# RE: Subgrade Inspection for Lot # 104 Manor at Stoney Creek – 4416 SW Tanzanite Cir Lee's Summit, MO 64082 – Permit # PRRES20212066

On June 7, 2021, a special inspection was performed by Everstead at the above referenced property. The purpose of this inspection was to determine structural adequacy of the existing soil for construction of concrete foundation.

SH 1	REVISION					
	0	TYPE	JT	SPREAD FOOTING DETAIL N.T.S.		EVERSTEAD ENGINEERING & DESIGN
	-	-	-			
	-	-	-			
	-	-	-			
	-	-	-			
	-	-	-			
	-	-	-

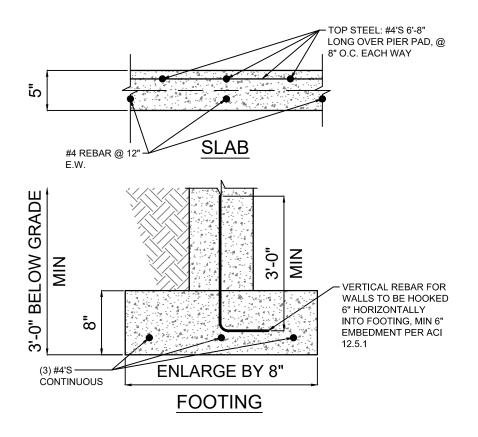
- The soils observed at footing elevation were silty clay; medium-dark brown; medium plasticity and dry.
- Probes and penetrometer readings indicated that the soils do not have sufficient bearing capacity for the loads applied by foundation per permit plans.

- Everstead recommends that the footings be enlarged to 24"X8" with three (3) #4 rebar continuous (see attached specifications)
- Basement and garage pier pads shall be enlarged a minimum of 6" each way (i.e existing 30"x30" shall be enlarged to 36"x36", etc.) (see attached specifications)
